# Access Compliance Report

## Public Rights-of-Way

Intersection ID: 44488	Main Street: CHALKSTONE_RD	Cross Street: FINN_HALL_AV	Location: S
ADA ID: 39955A54921C	Ramp Type: BlendTrans1	Initial Pass/Fail: Fail	Overall Compliance: No
		Severity Score: 10

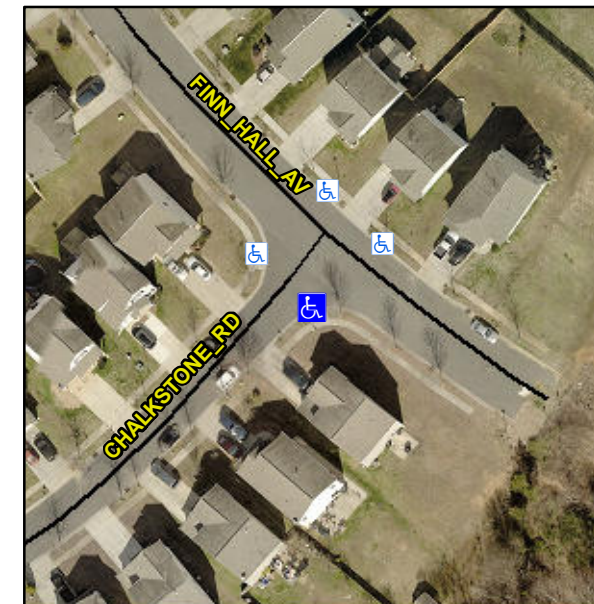
**Not Found, R304.5.1, R304.5.3**

Compliance	Description	Data	Compliance	Description	Data
N/A	Ramp Length (in)	52.0	Yes	BlendTrans Slope (%)	2.6
No	Ramp Width (in)	46.5	No	BlendTrans XSlope (%)	3.3
N/A	Flare Type LT	N/A	N/A	Flare Type RT	N/A
N/A	Flare Slope LT (%)	N/A	N/A	Flare Slope RT (%)	N/A
N/A	Flare Traversable LT?	N/A	N/A	Flare Traversable RT?	N/A
N/A	Landing Length (in)	N/A	N/A	DWS Provided?	N/A
N/A	Landing Width (in)	N/A	N/A	DWS Contrast?	N/A
N/A	Landing Slope (%)	N/A	N/A	DWS Length (in)	N/A
N/A	Landing X Slope (%)	N/A	N/A	DWS Full Width?	N/A
N/A	Landing Curb? (Y/N)	N/A	N/A	DWS Offset (in)	N/A
N/A	Shared Landing?	N/A			
N/A	Gutter Ponding?	N/A	N/A	Gutter Slope (%)	N/A
N/A	Gutter Lip Ht (in)	N/A	N/A	Gutter X Slope (%)	N/A
N/A	Painted X Walk1?	No	N/A	Painted X Walk2?	No
	X Walk 1 Direction	To NE		X Walk 2 Direction	To NW
	X Walk 1 Width (in)	N/A		X Walk 2 Width (in)	N/A
	X Walk 1 Slope (%)	0.4		X Walk 2 Slope (%)	1.1
	X Walk 1 X Slope (%)	1.4		X Walk 2 X Slope (%)	3.3

N/A	Ramp inside XWalk1?	N/A	N/A	Ramp inside XWalk2?	N/A
	Road Slope (%)	3.2		Clear Space?	N/A
	Road X Slope (%)	3.6	N/A	Clear Space to XWalk (in)	N/A
N/A	Any Obstructions?	N/A	N/A	Storm Grate/Utility Hazard?	N/A
	Obstruction Type			Storm Grate/Utility Type	
		N/A			N/A
			Yes	Surface Condition? (G/P)	Good
			No	Curb Slope (%)	8.3

**Remove & Replace Curb Ramp With Two New Directional Ramps or Equivalent.**
